Facility: Grindstone Nature Area

Address: 2011 Old Hwy 63 S. Date of Survey: 04/17/10

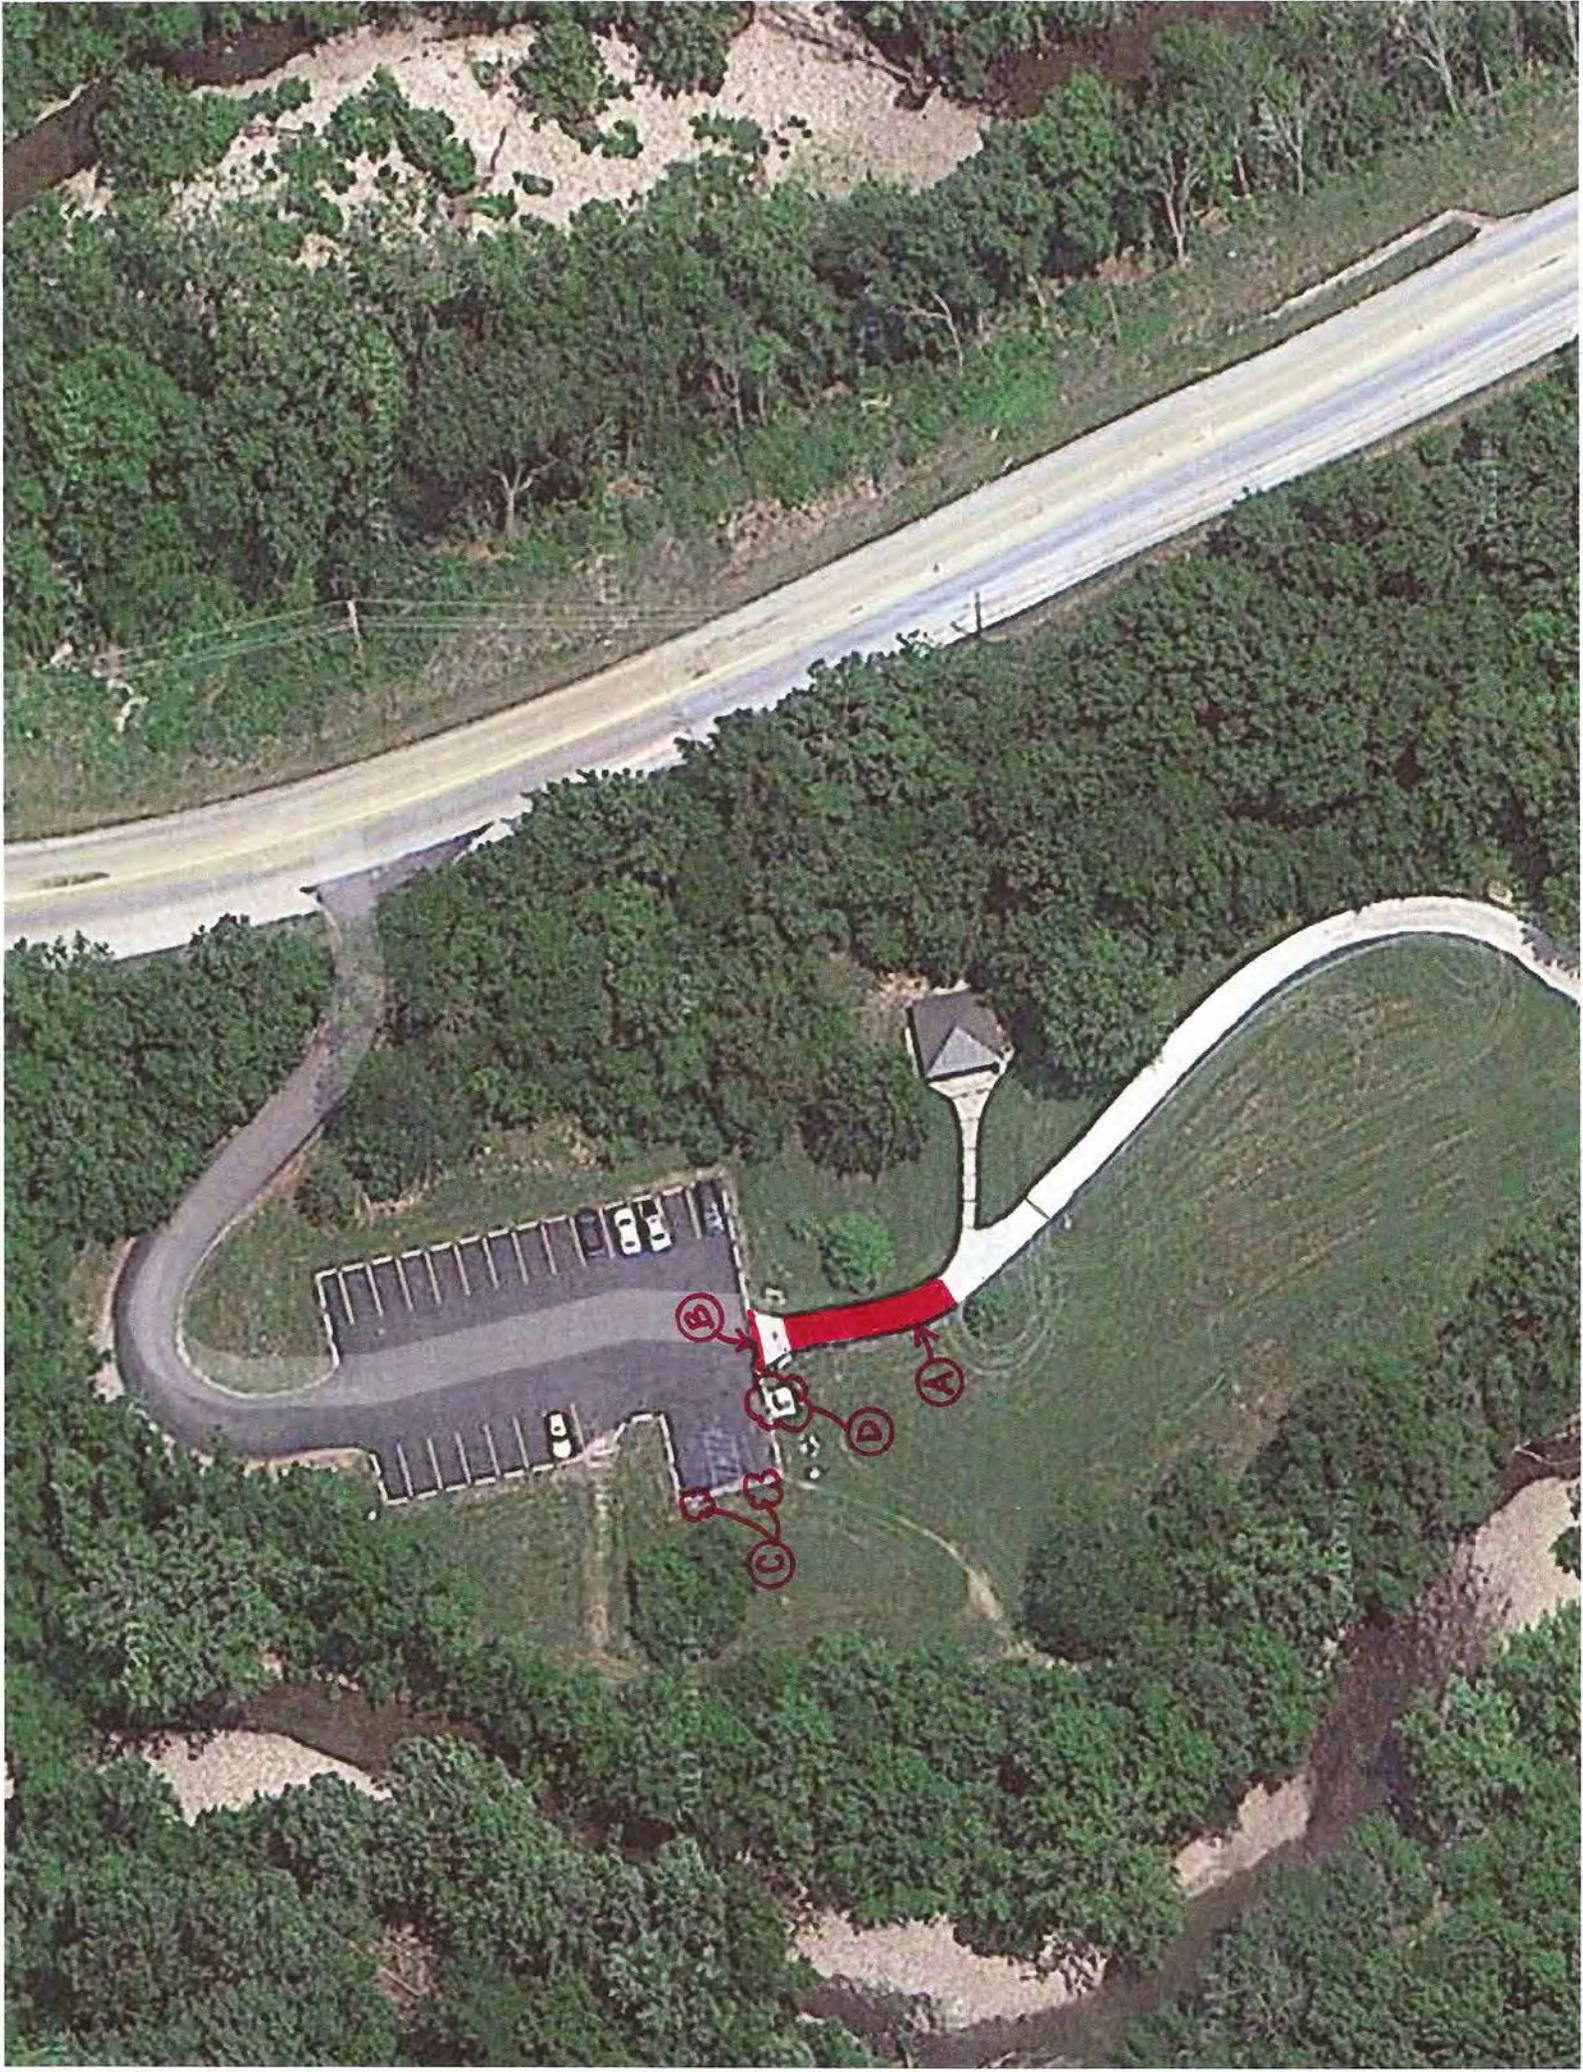
- Refer to site plan included with this report: (A) Remove ~ 9.5' wide x 50' long section of concrete sidewalk that has slopes and cross-slopes up to 10% and replace with new concrete access walk w/ max. slope of 5% and max. cross-slope of 2% or as close to those maximum slopes as is feasible (B) Patch/grind asphalt to create a smooth transition from parking lot to sidewalk (see photo 1 next page). **Estimated Cost: \$4,384.00**

- Refer to site plan included with this report: (C) Parking lot has 23 total parking spaces, therefore one ADA parking space is required. Two ADA parking spaces are currently provided, but only one sign is provided. Move the existing ADA parking sign and install on a post at 72" above grade and install an new sign at the other parking space: **Estimated Cost: \$177.00**

- Refer to site plan included with this report: (D) Replace non-accessible portable toilet with a wheelchair accessible portable toilet (no cost figured in this estimate) and replace ~ 36 s.f. concrete pad that portable toilet sits on for accessibility (see photo 2 below). **Estimated Cost: \$998.00**
